CONCOURSE "D" REMODELING AND GATE ADDITION

GENERAL MITCHELL INTERNATIONAL AIRPORT

AC-3 THROUGH AC-6

Architectural Document Clarification to:

Architect's Job 87737 c1
Sheet Number AC-3.1

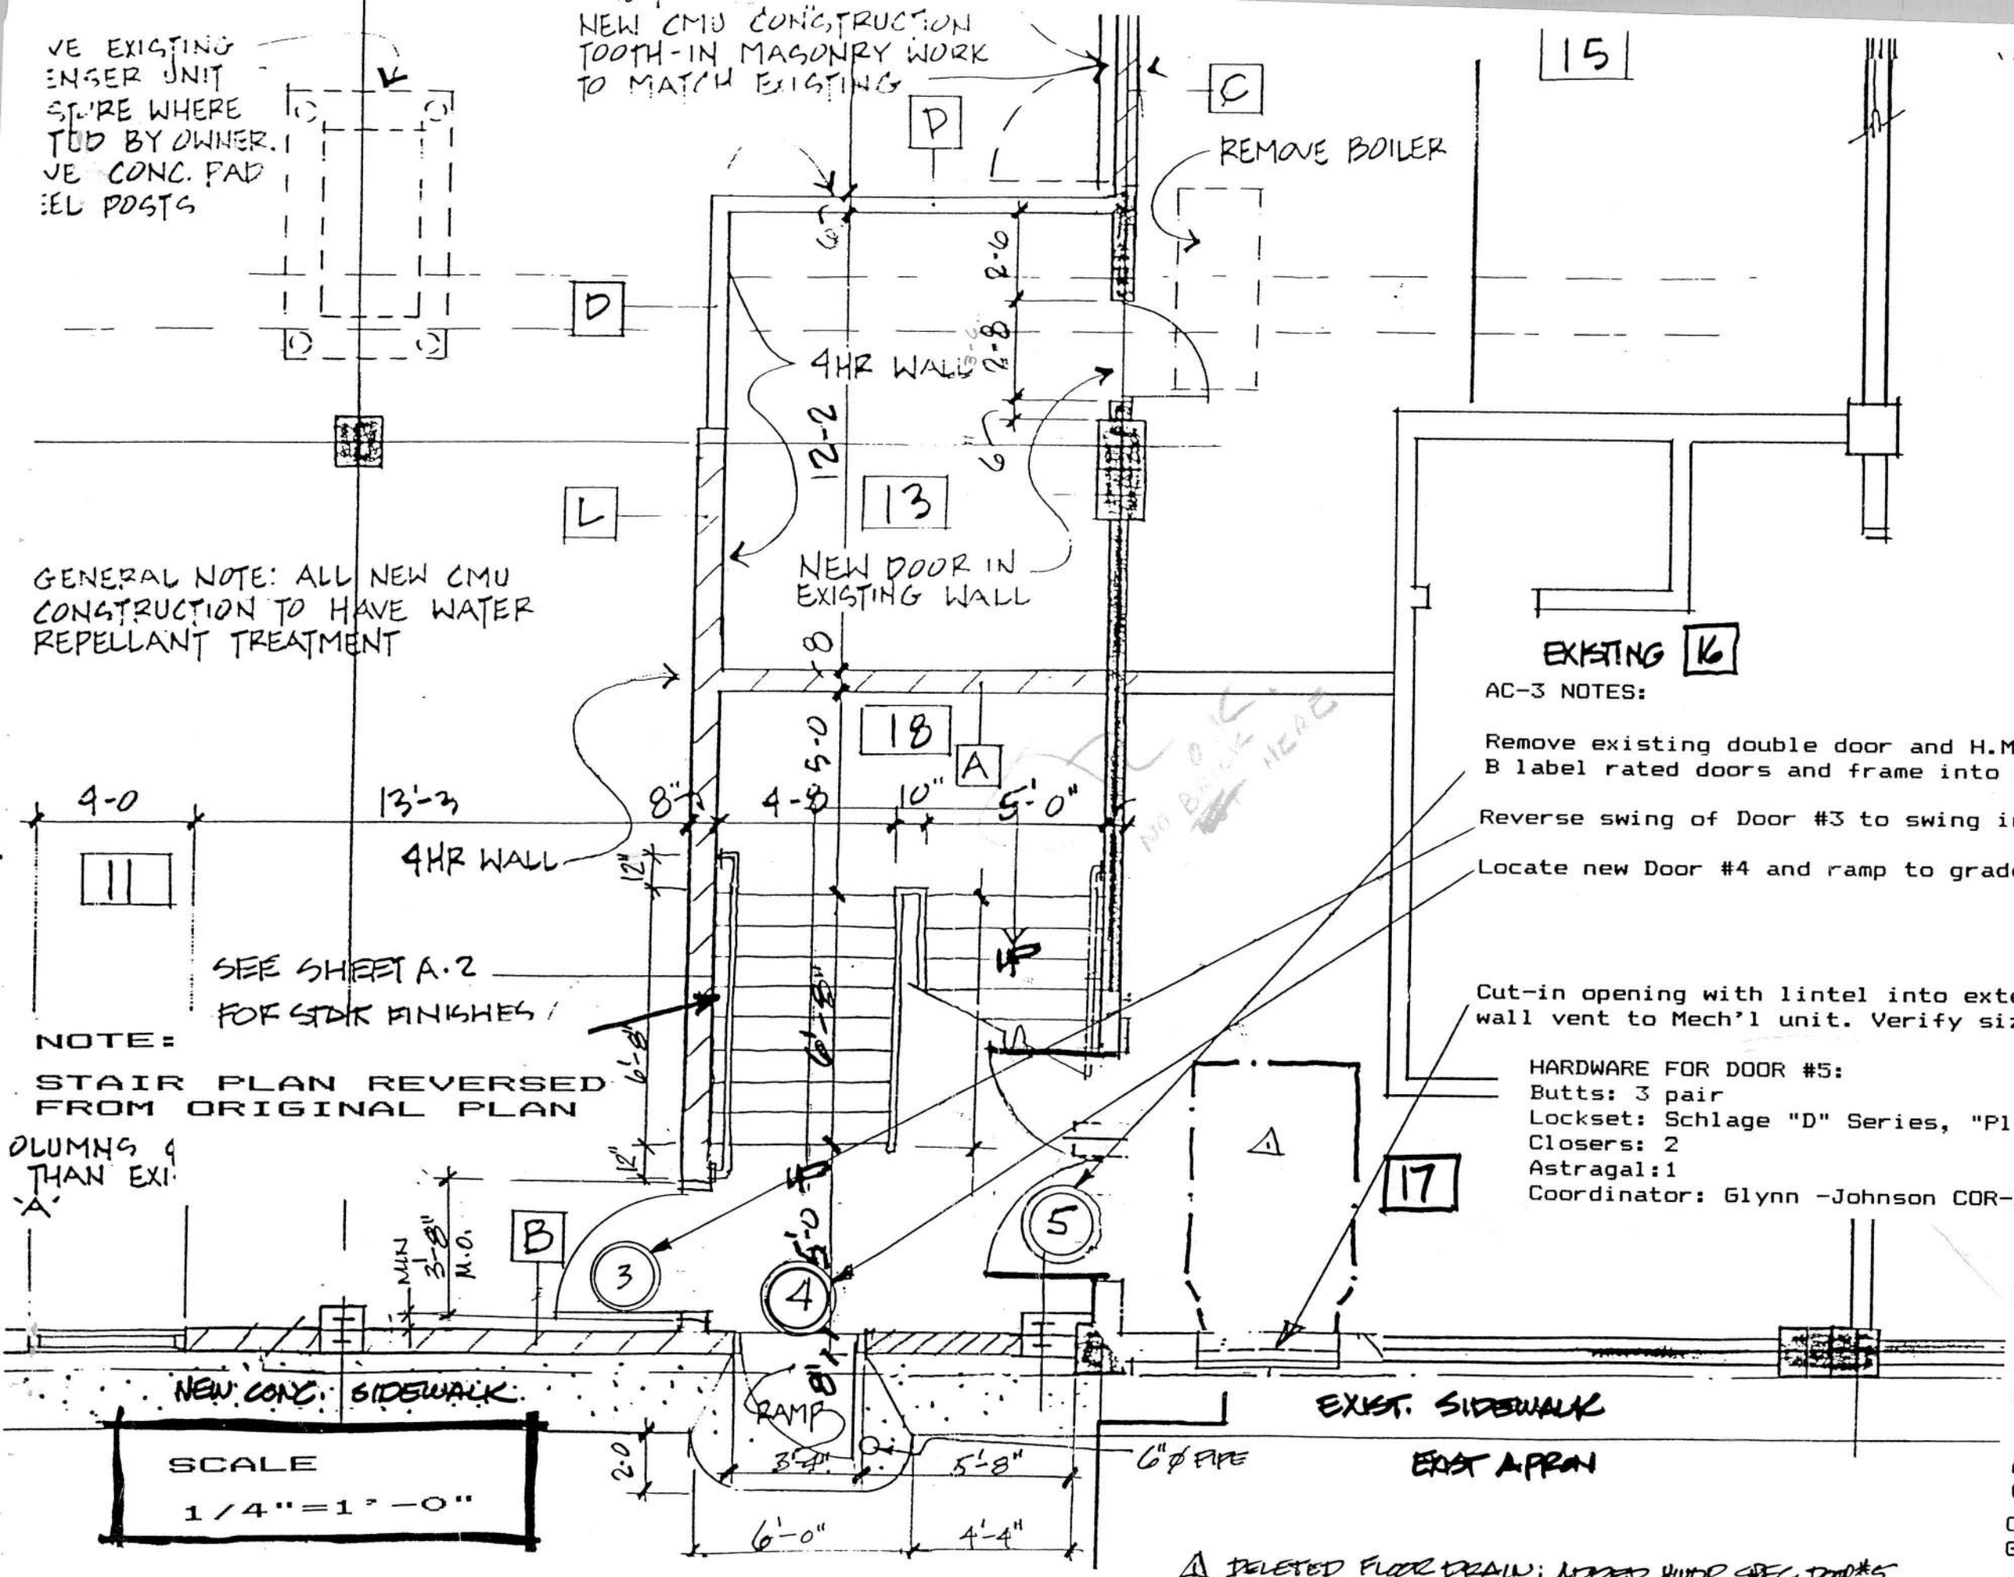
AC-3 NOTES:

Remove existing double door and H.M. frame and install new B label rated doors and frame into existing opening.

Reverse swing of Door #3 to swing into Room #11.

Locate new Door #4 and ramp to grade as shown.

Cut-in opening with lintel into exterior wall for through-wall vent to Mech'l unit. Verify size and location.

HARDWARE FOR DOOR #5:
Butts: 3 pair
Lockset: Schlage "D" Series, "Plymouth Design", D 70 PD
Closers: 2
Astragal: 1
Coordinator: Glynn -Johnson COR-2

△1 DELETED FLOOR DRAIN; ADDED HWDR SPEC DOOR #5
3.8.88

NOTE: STAIR PLAN REVERSED FROM ORIGINAL PLAN

1) Stair plan has been reversed from original plan.

2) Handrail at West wall upper landing to be minimum 2" away from existing brick and continue straight and parallel to center railing to 12" beyond last riser at midlanding. Because existing brick stops part way down stairs, handrail will be 6" from existing wall at lower end.

3) OPENINGS:

Provide openings as shown for ducting to be installed by others.

Construction of the openings, 2 hour rated ceiling construction and other rated construction to be coordinated by Construction Manager as part of work being performed under this contract.

If ducting and fire proctection systems by others are not in place when work being performed under this contract is completed, openings shown are to be filled in with masonry knockout panels by Masonry Contractor.

1 AC5 SECTION: N/S AT STAIRS

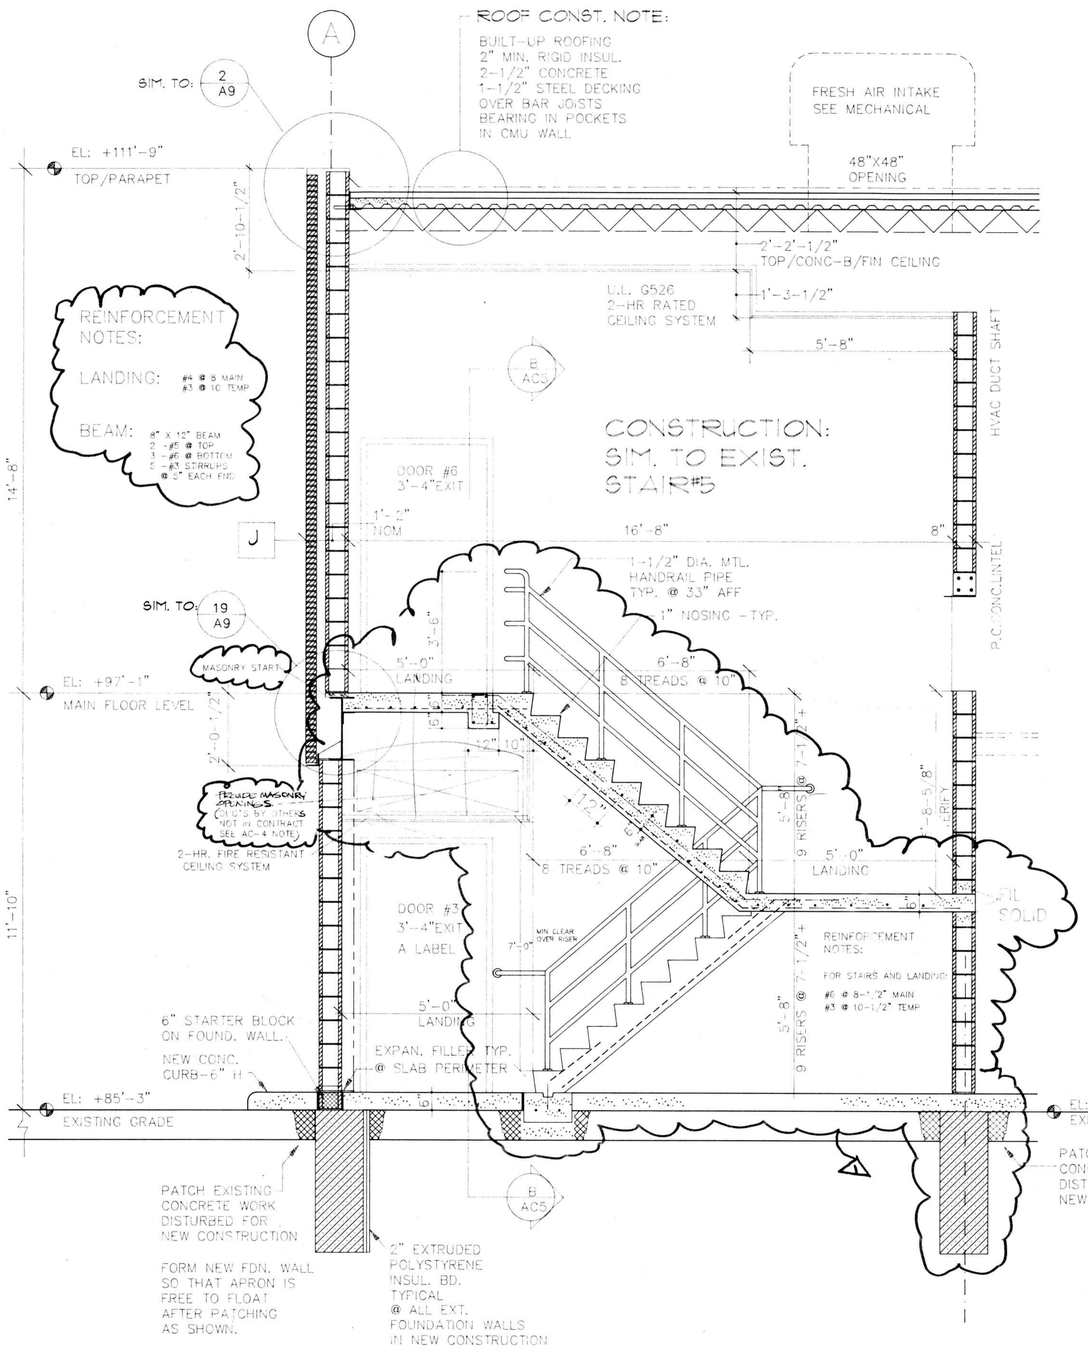
1 CHANGES FROM DRAWING A-5-3.9.88 FILE

Sheet Number AC-6

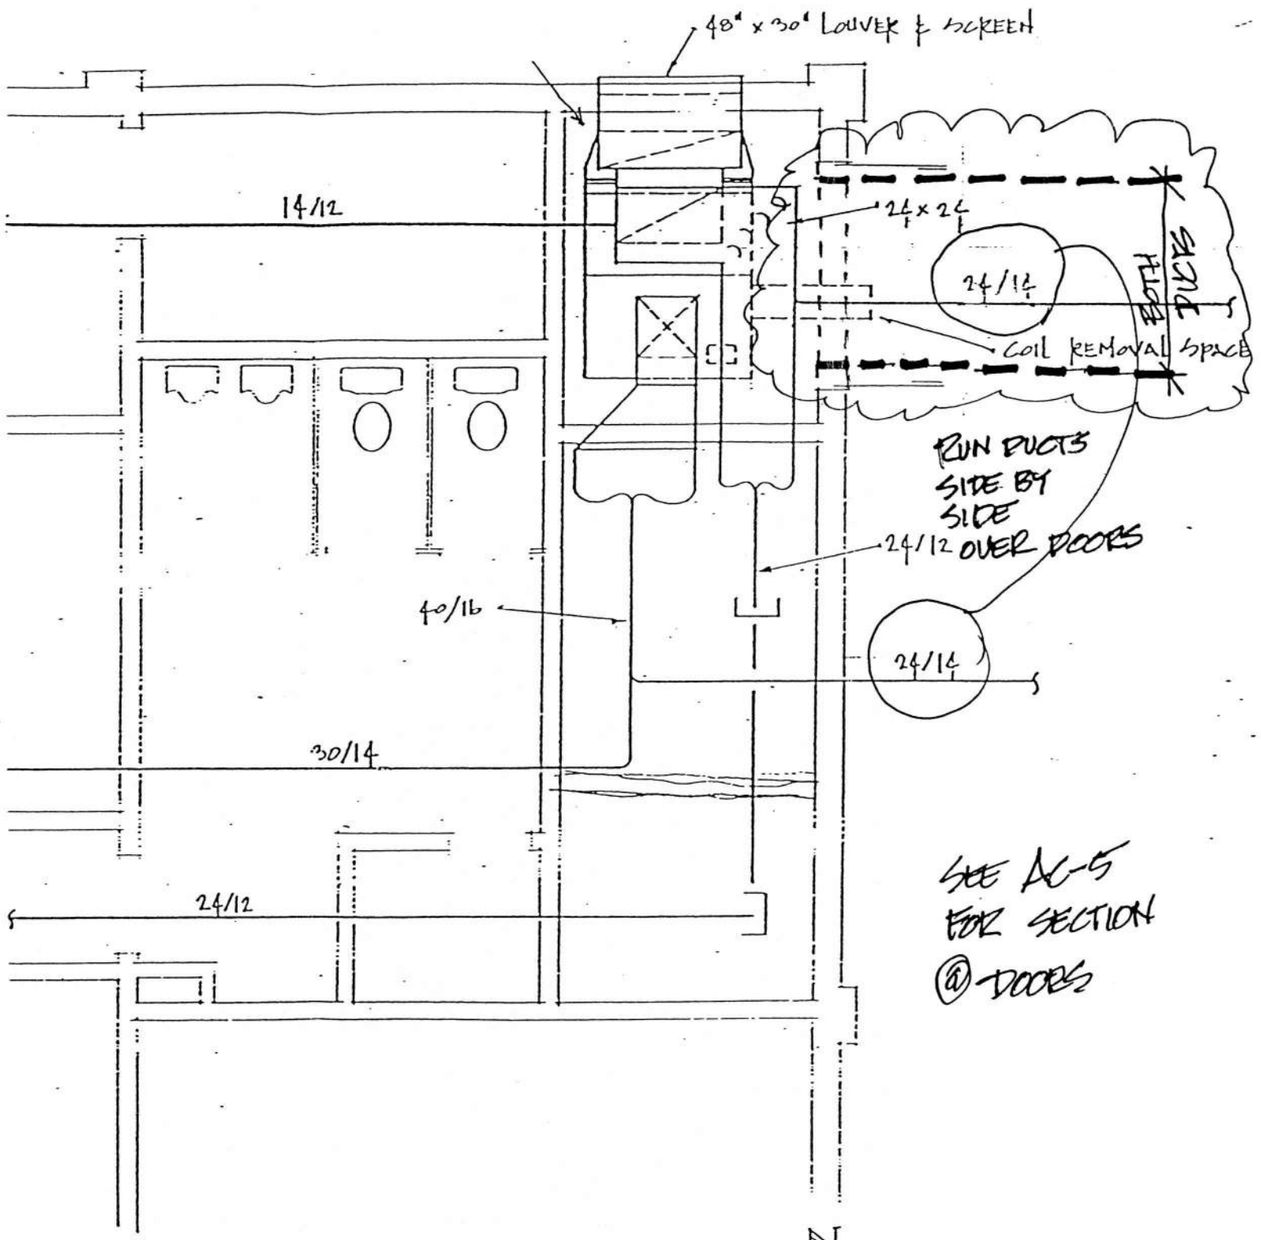
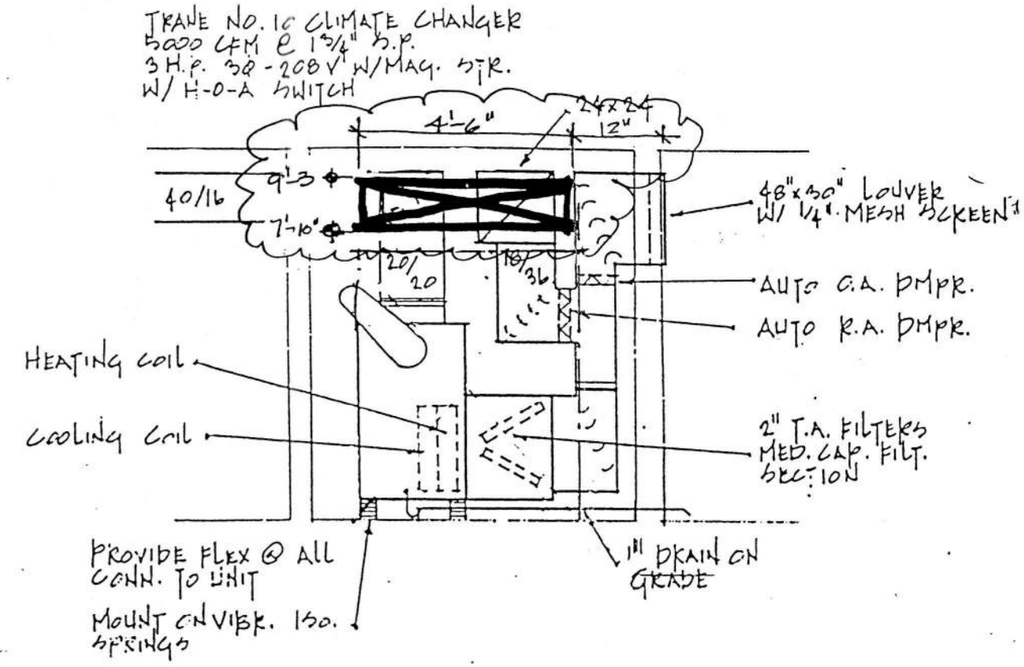
SEE AC-5 FOR SECTION @ DOORS

22 A-9 DROPPED SOFFIT DETAIL 1"=1'-0"

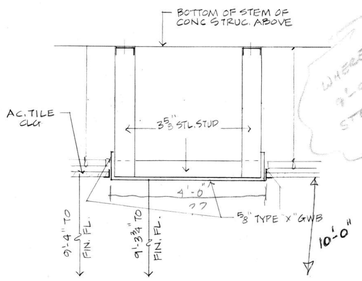
WHERE IS 9'-9" STEP?
